**ADDENDUM NO 2
TO
CONTRACT DOCUMENTS
FOR
FINISHED WATER PUMP VAULT VENTILATION

DISTRICT PROJECT NO. 4371

7/20/2026**

FINISHED WATER PUMP VAULT VENTILATION

A FINISHED WATER PUMP AREA - PLAN
SCALE: 3/16" = 1'-0"
FILE: 02-M-24

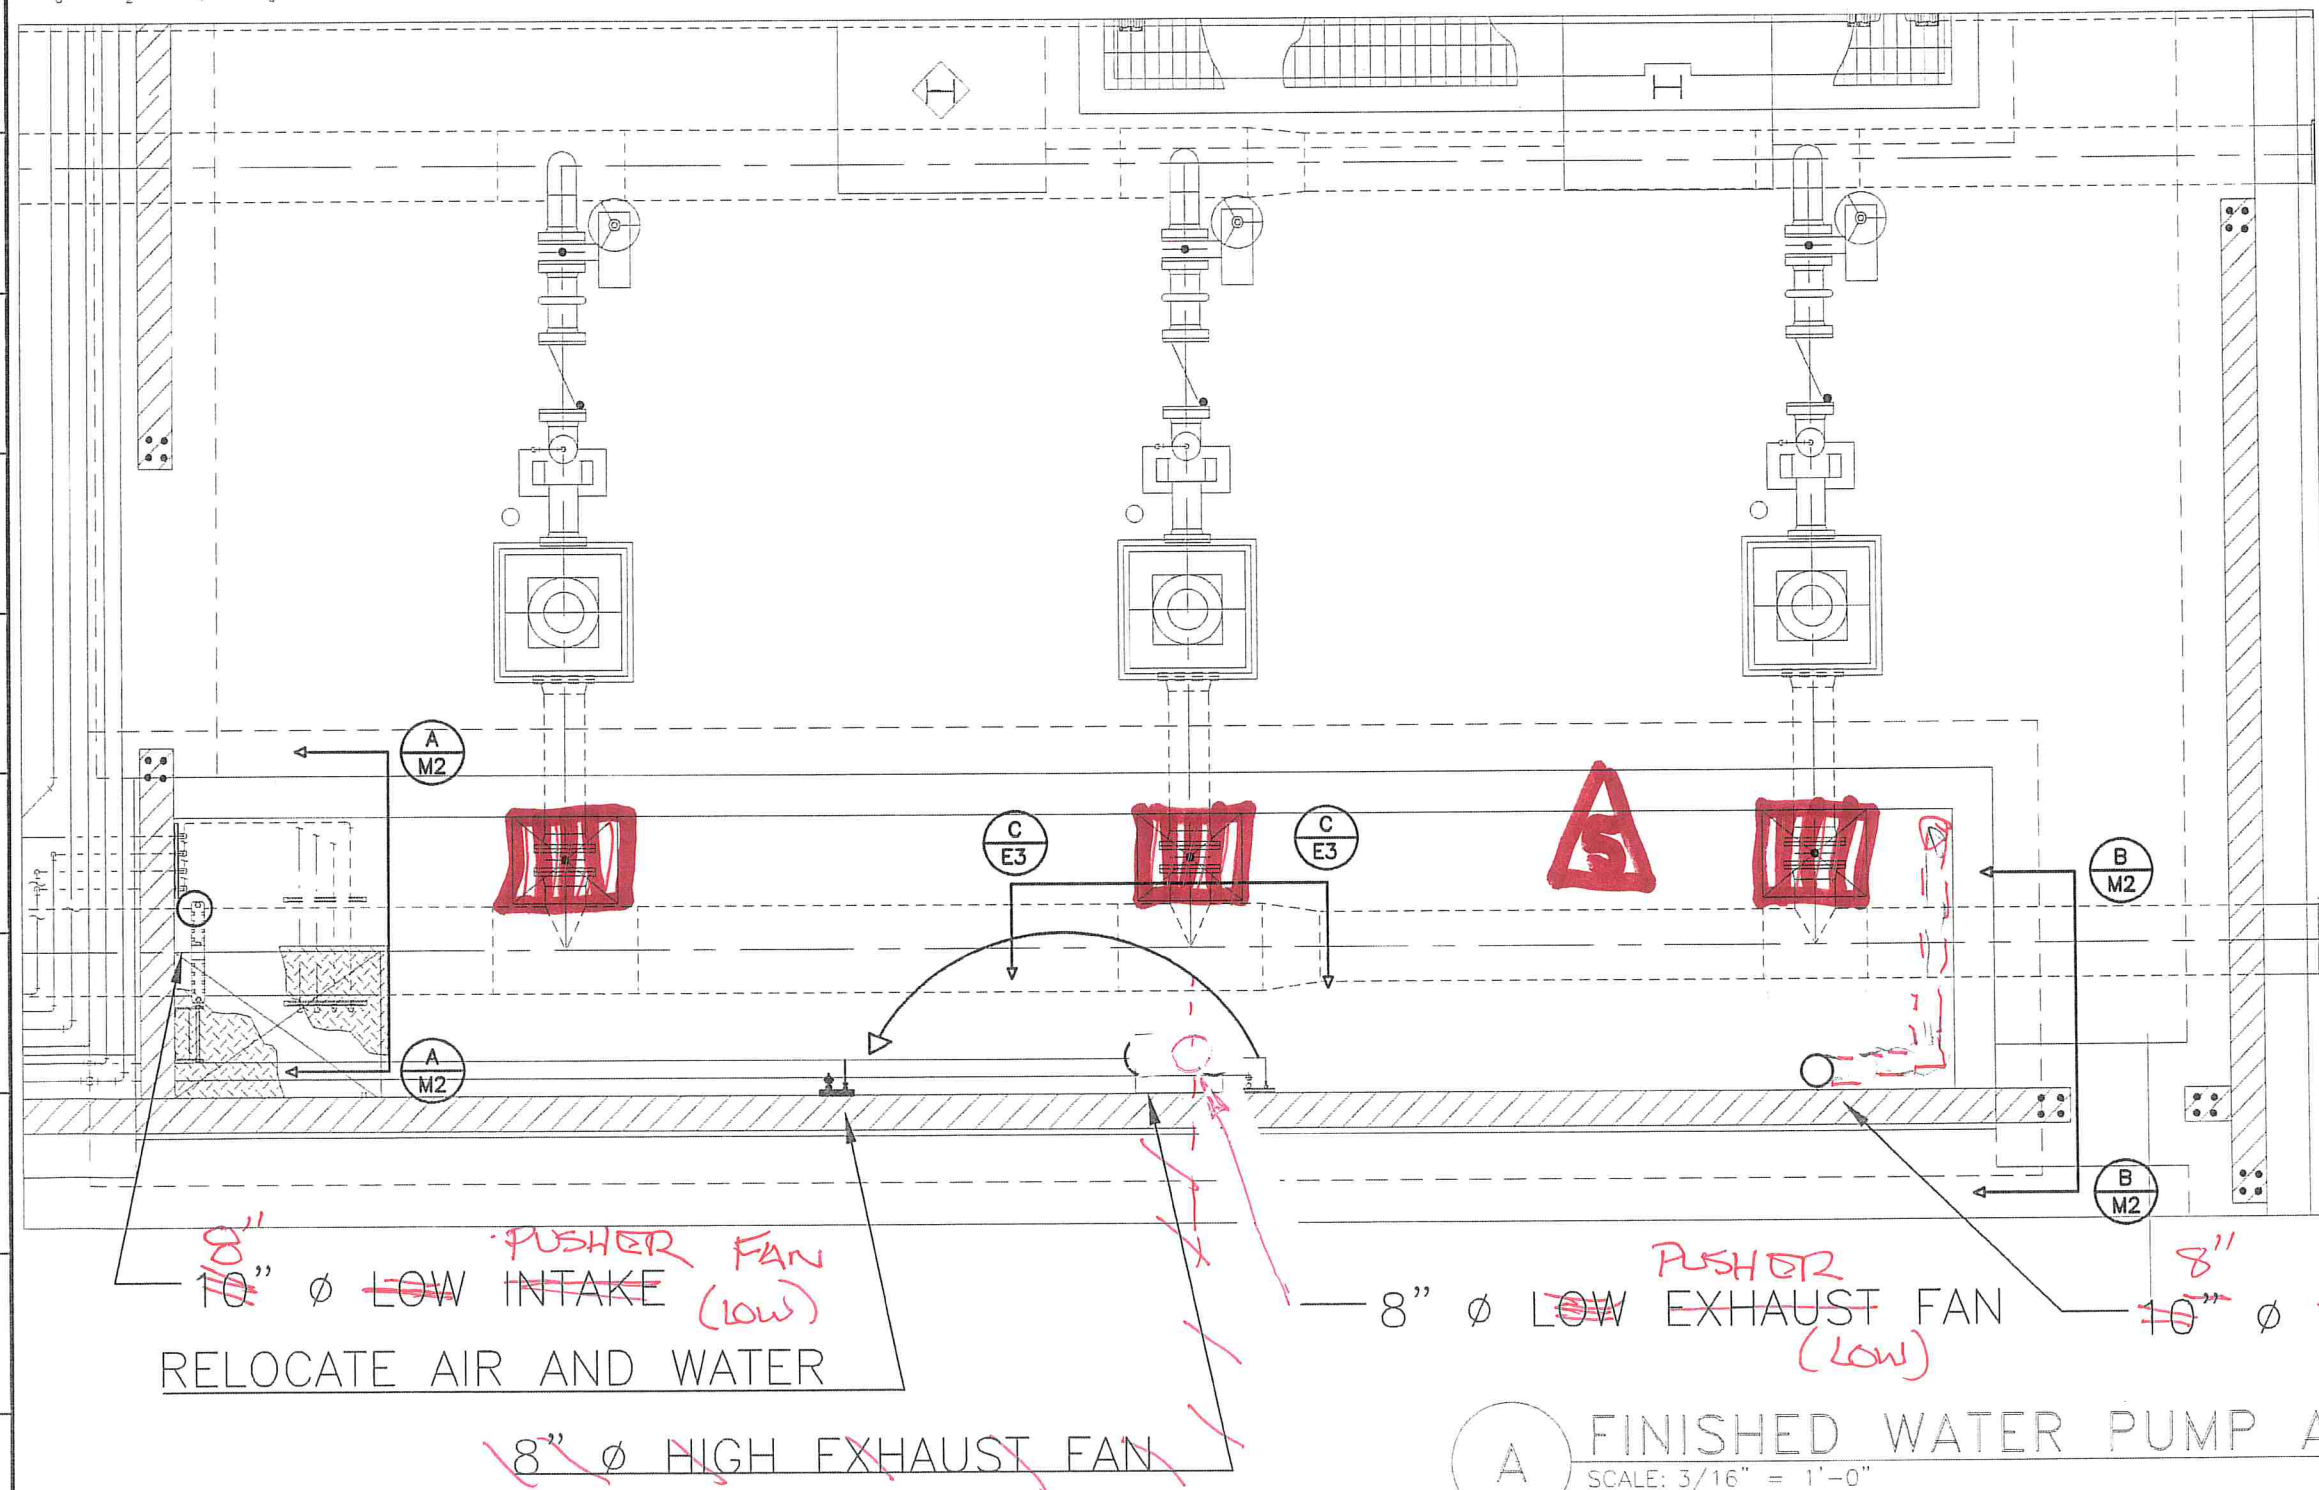
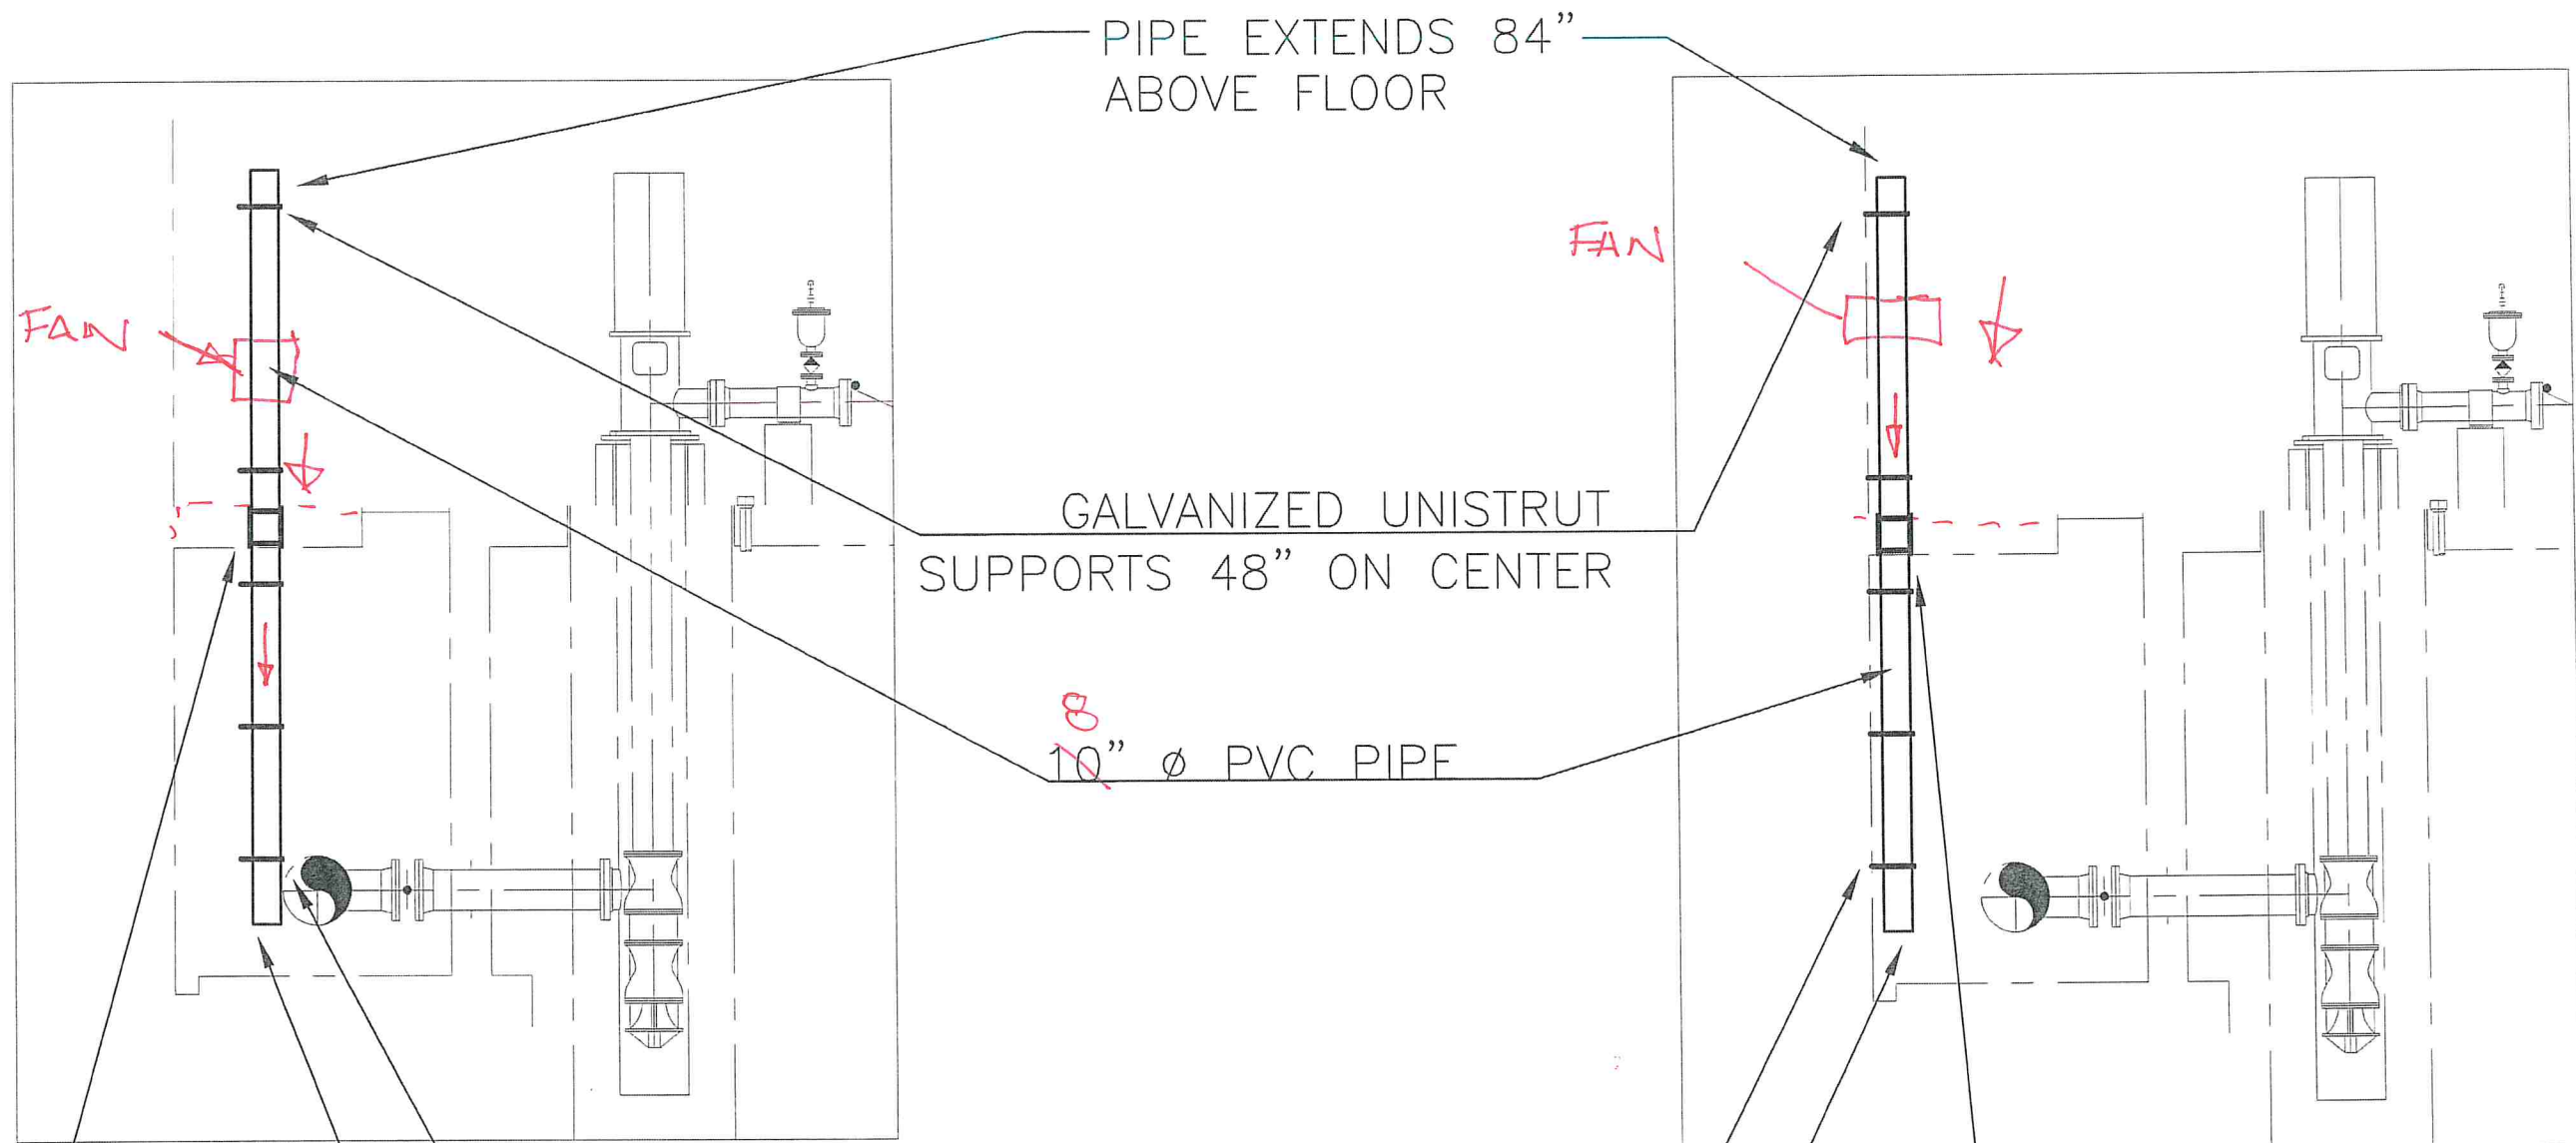
5. DEMOLISH DIAMOND PLATE. REPLACE WITH FRP FLOOR GRATING 35'x41' VERIFY IN FIELD

1. Replace **three** diamond hatch plates with (35"x41") with FRP bar grating to match existing grating in room. Contractor to field verify dimensions of hole under plate prior to fabrication.
2. Project shall include **three** fans in lieu of **two**. All shall have "pusher" orientation into vault. Contractor shall install new "rigid conduit" to each fan running in parallel from one fan timer.
3. Lighting for the vault should include **two** wall mounted light fixtures in lieu of four. Locate on the wall 84" above finished floor.
4. Provide **one** light switch and **one** HOA switch outside of the vault on the building interior wall near entrance. Install rigid conduit to match existing site as necessary for a fully functional system.
5. Provide one Flood switch routed back to programmable logic controller via existing conduit (assume 100' conductor)

A FINISHED WATER PUMP AREA - PLAN
SCALE: 3/16" = 1'-0"
FILE: 02-M-24

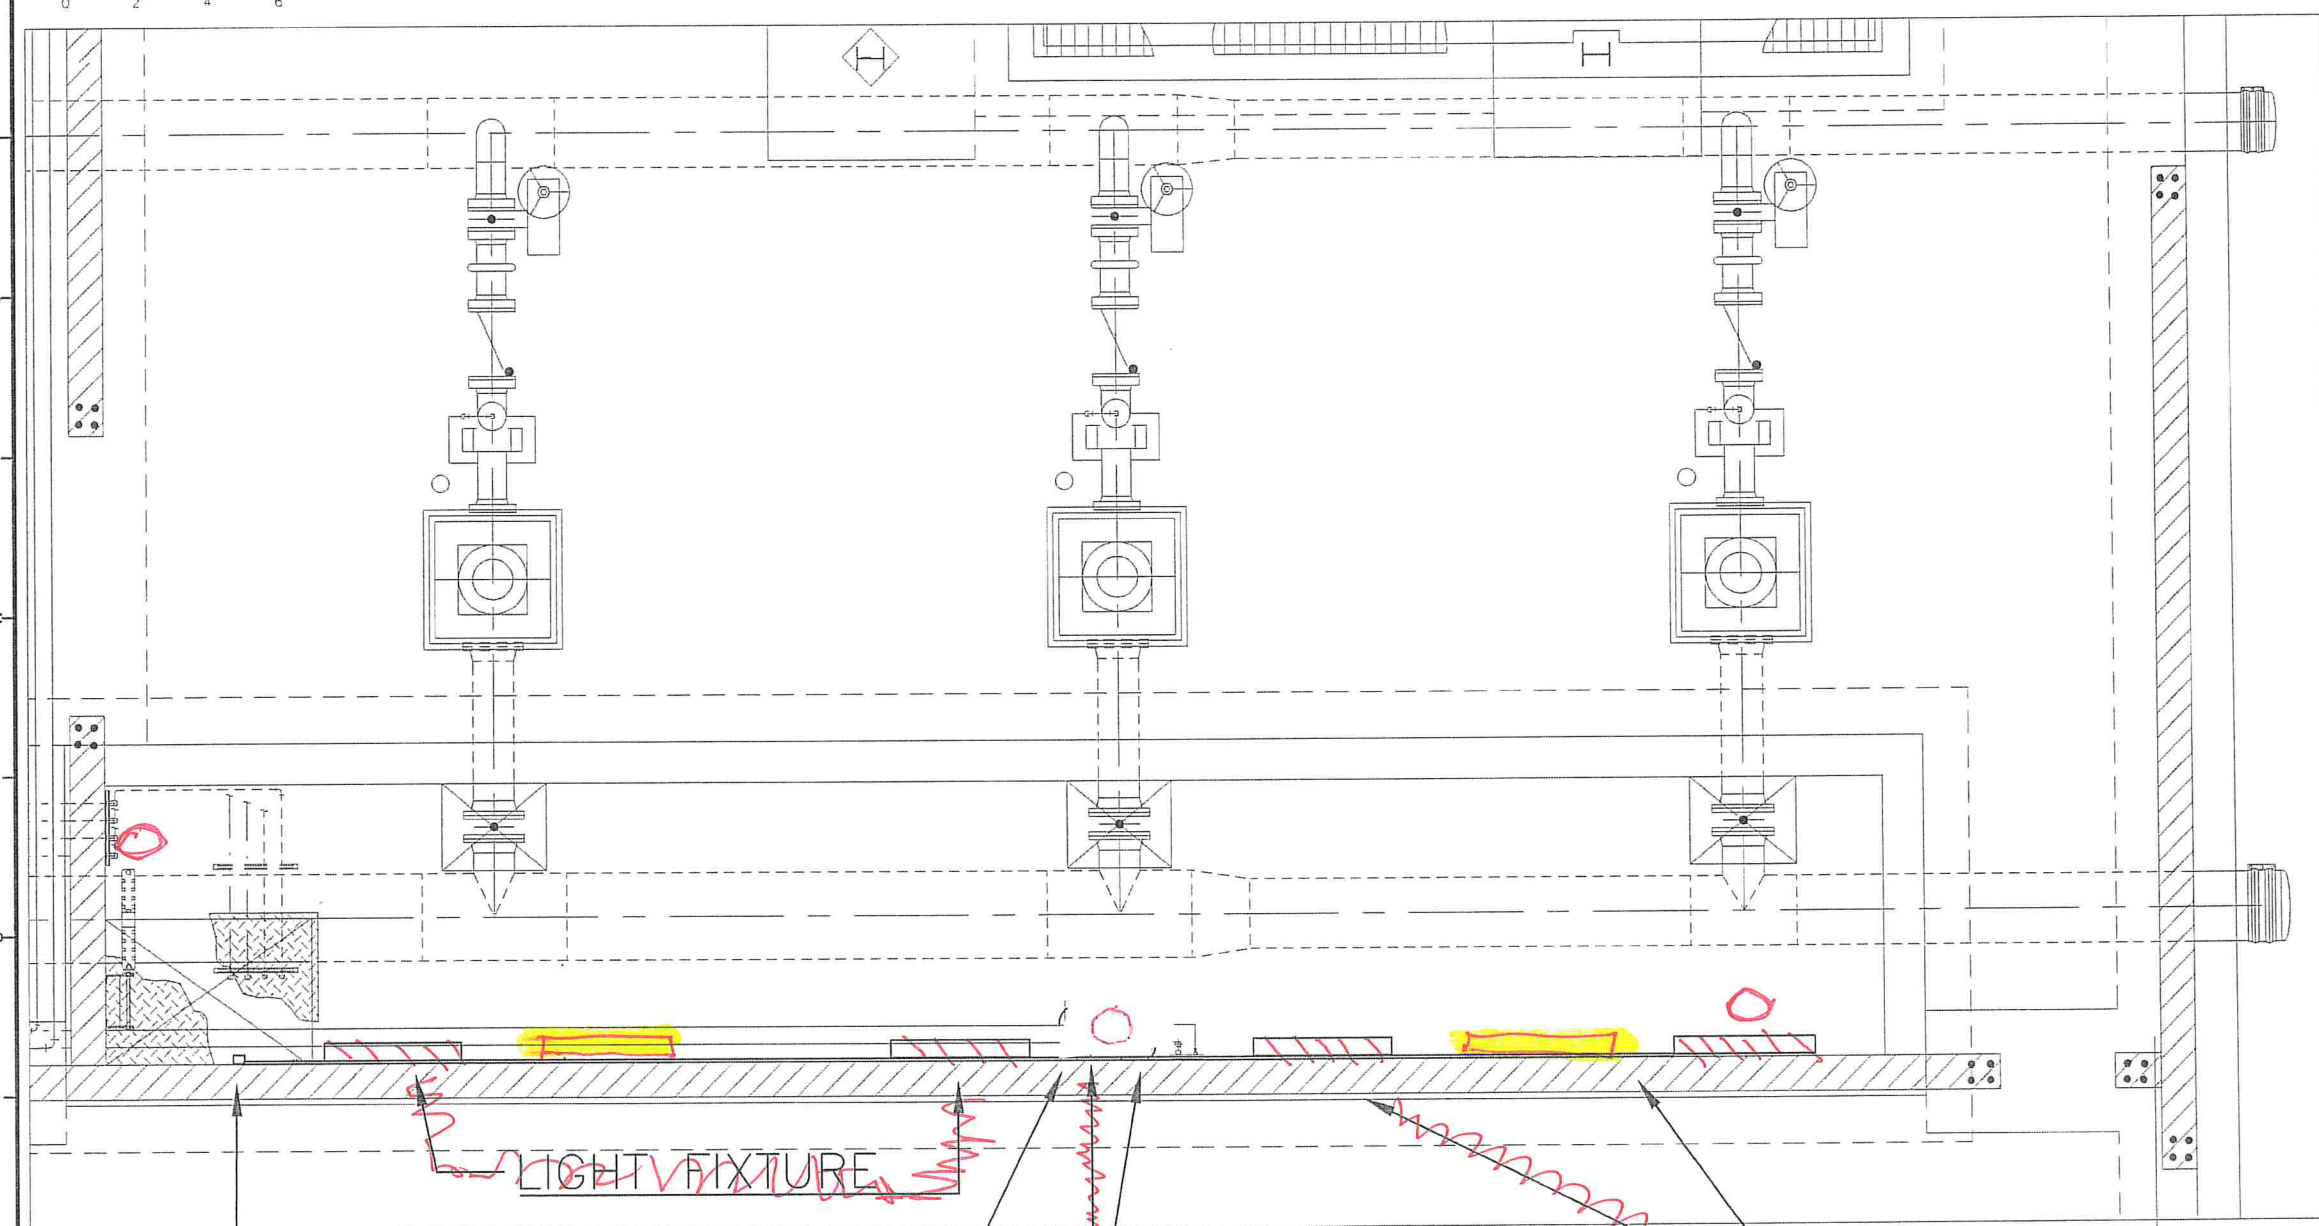
8"Ø EXHAUST FANS ~~3~~ X 3
